## CITY OF NAPOLEON - BUILDING DEPARTMENT 255 West Riverview Avenue, Napoleon, Ohio 43545 - 419-592-4010

# CITY OF NAPOLEON BUILDING INSPECTION DEPARTMENT APPLICATION FOR BUILDING PERMIT (Please print or type)

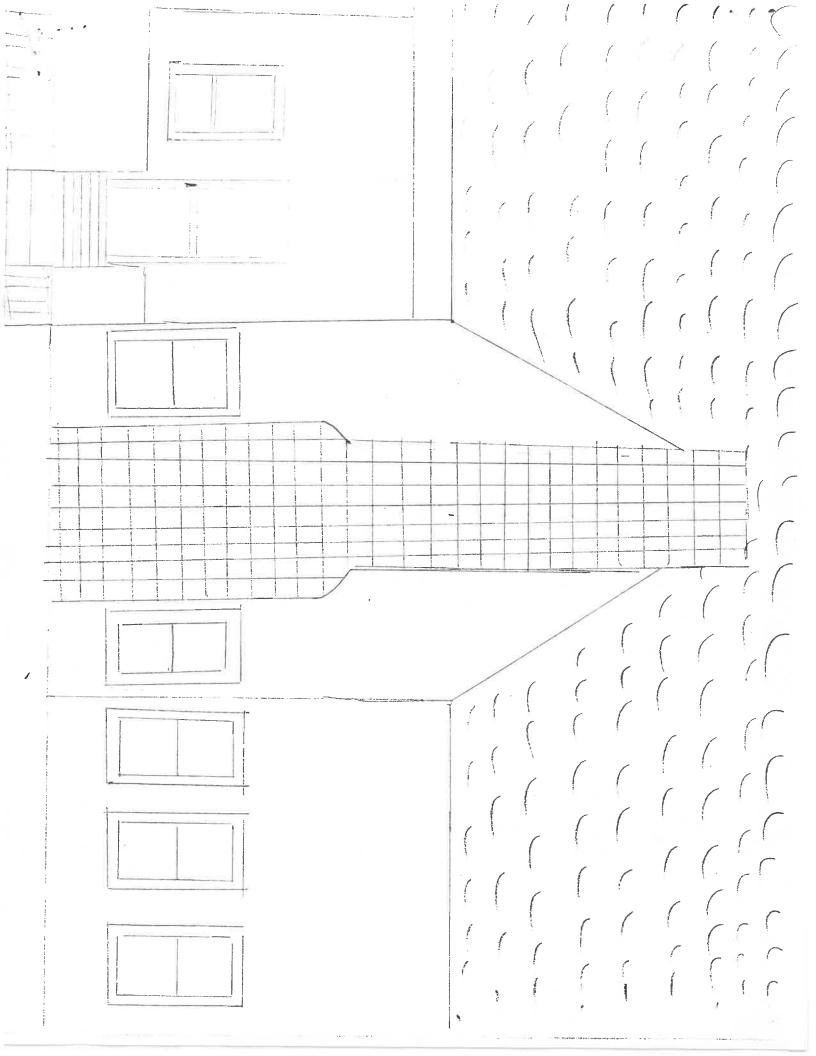
# NEED FOUNDATION [NEORMATION

FOORDATION WALL No less than 8" wide and 32" dep

FOOTER SIZE & DEBTH No less than 6" thick

\$ 12" wide

3-0" 3-0" AMDING ON EXTERIOR

SIDE OF DOOR MAX 8"2" BECOME

MAX STAIR RISERS = 8"

MIN STAIR TREDI = 9"
